ADDENDUM NO.2

This addendum forms a part of the Contract Documents and modifies the original Bidding Documents dated March 11, 2011 as noted below.

Thomas County Historical Courthouse Renovation

SK-1
PLUMBING SKETCH FOR WATER
AND SEWER LINE LOCATIONS

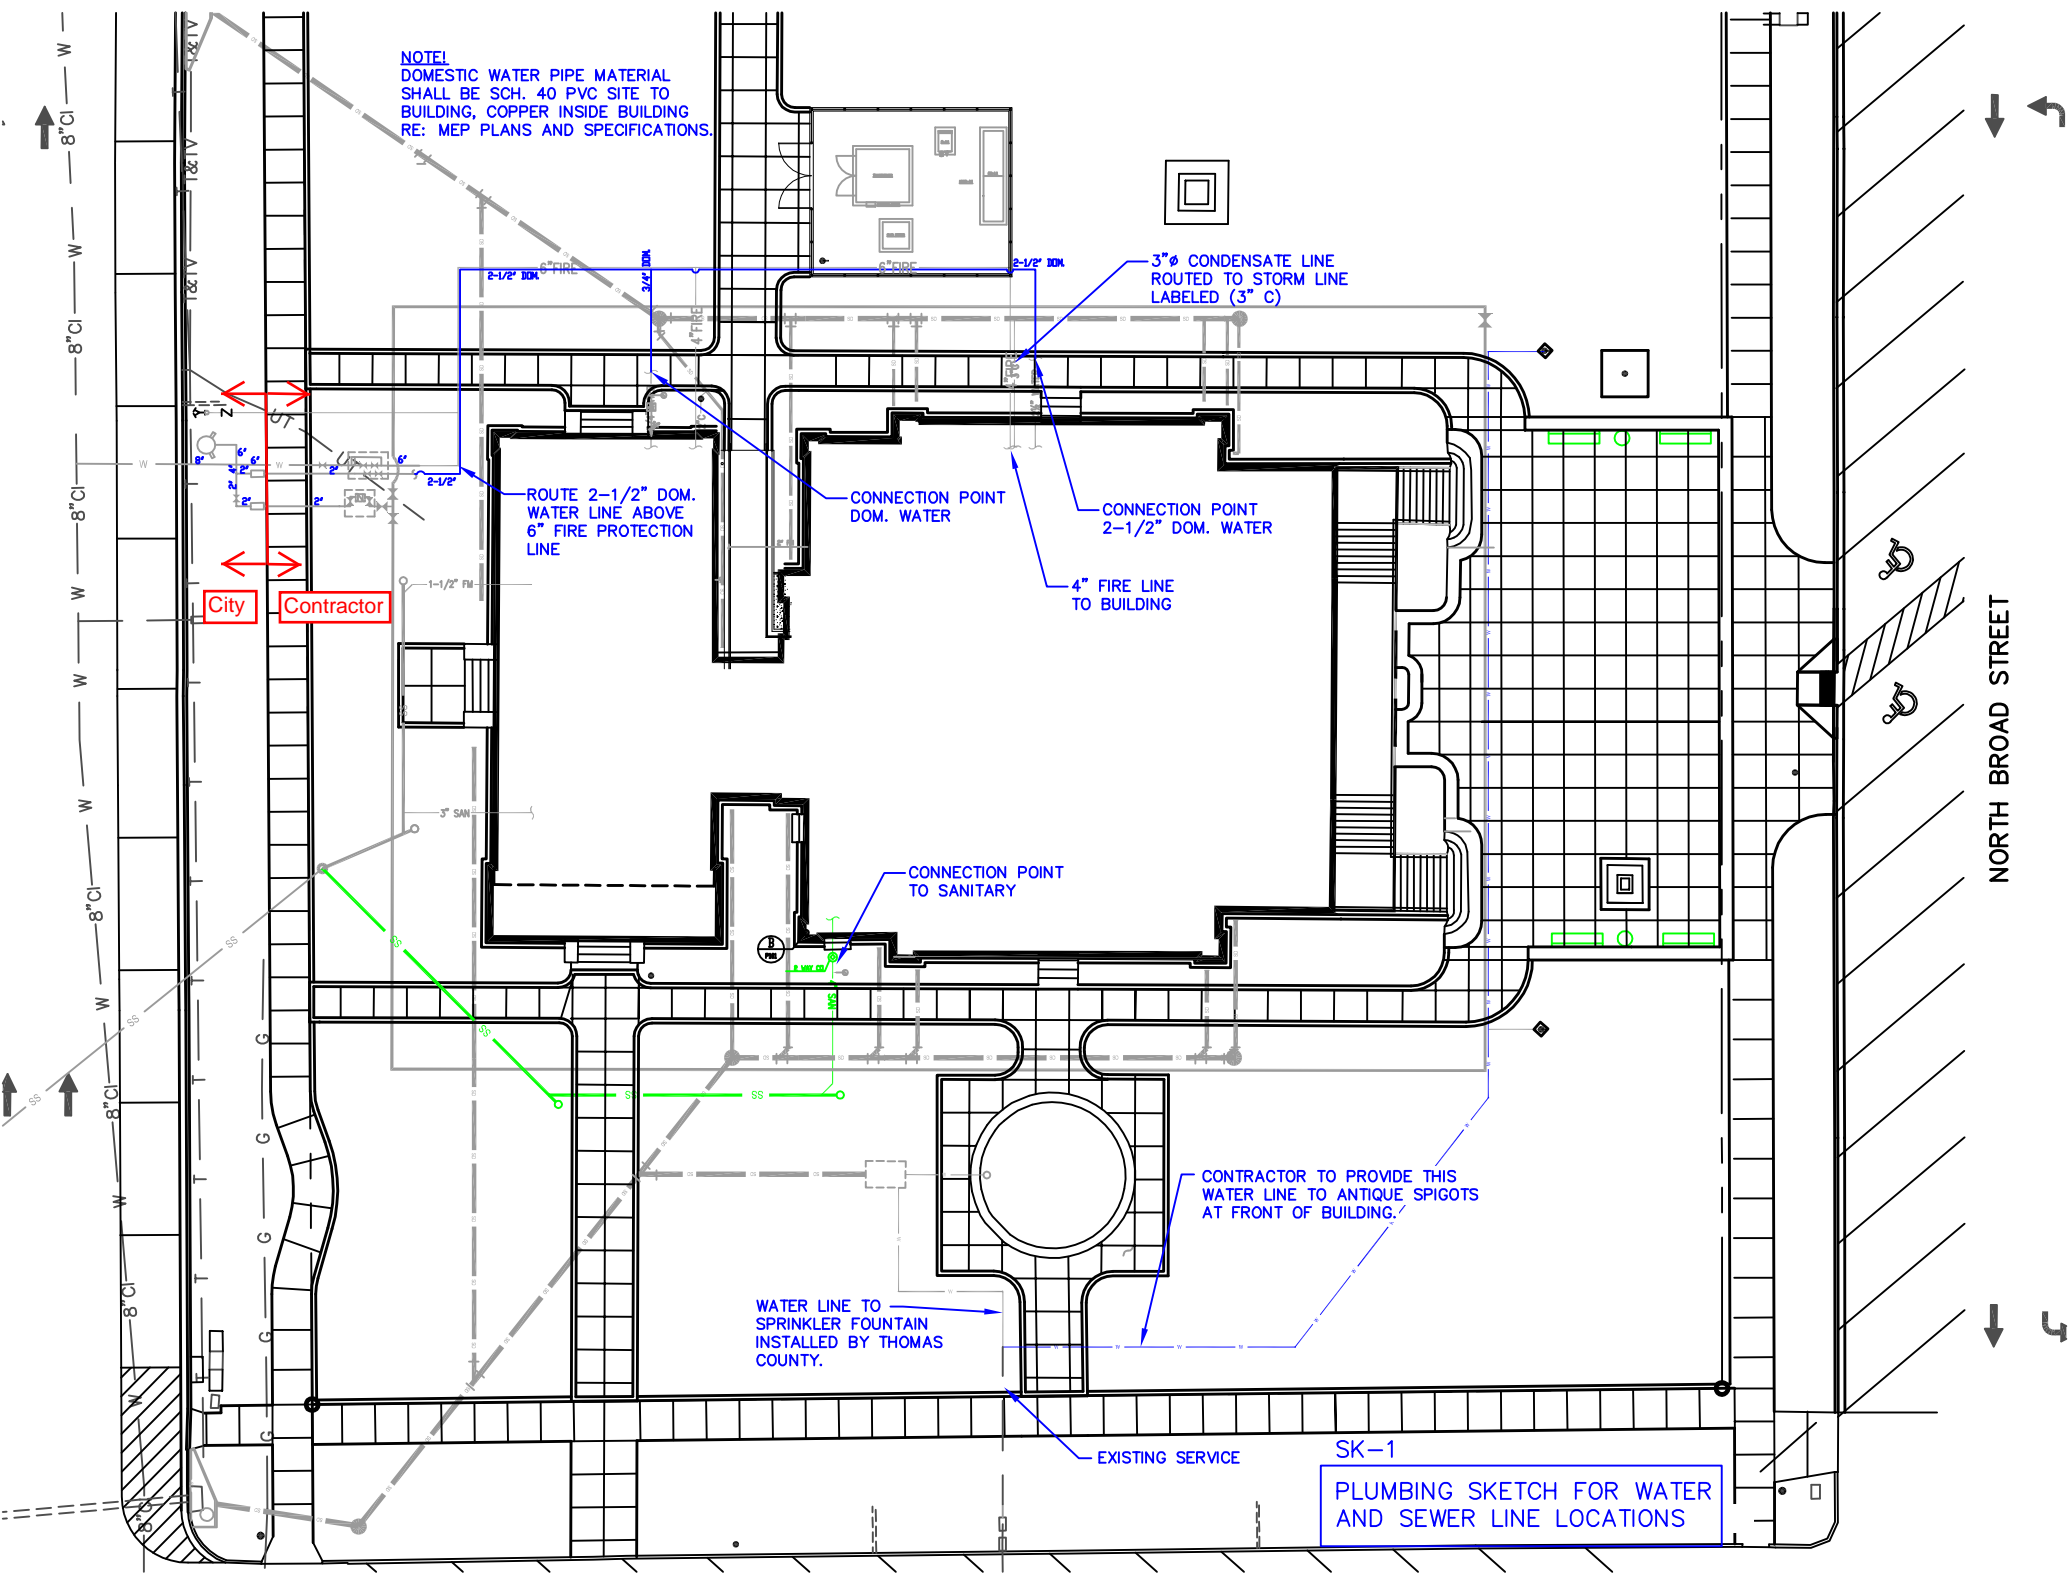
1. Where do potable water lines run on site plan that enter the building as shown on P201, Detail A? Where does sewer line run on site plan?

Answer: For potable water entrance, see P101, Detail A at Mechanical Room 112. See F002. See attached site plan sketch showing potable water line and sanitary sewer line locations based on Sheet L008. The contractor is responsible to tee off from the existing water line going to the

water fountain on the south side of the main building, and provide the new water line to serve the antique spigots on the Broad Street side of the building on each side of the plaza. Note the 4" fire suppression line shown on L008 should be 6" fire suppression line per Sheet F002. Note revised piping that serves new fire hydrant. Note corrections to callout notes on Sheet F002: new fire department siamese connection – See Detail "C/F201"; new post indicator valve – See Detail "B/F201"; new double detector check valve – See Detail "A/F201". Note 2 ½" potable water line size coming out of backflow preventer vault to serve building.

ROUTE 2-1/2" DOM.
WATER LINE ABOVE
6" FIRE PROTECTION
LINE

CONTRACTOR TO PROVIDE THIS
WATER LINE TO ANTIQUE SPIGOTS
AT FRONT OF BUILDING.
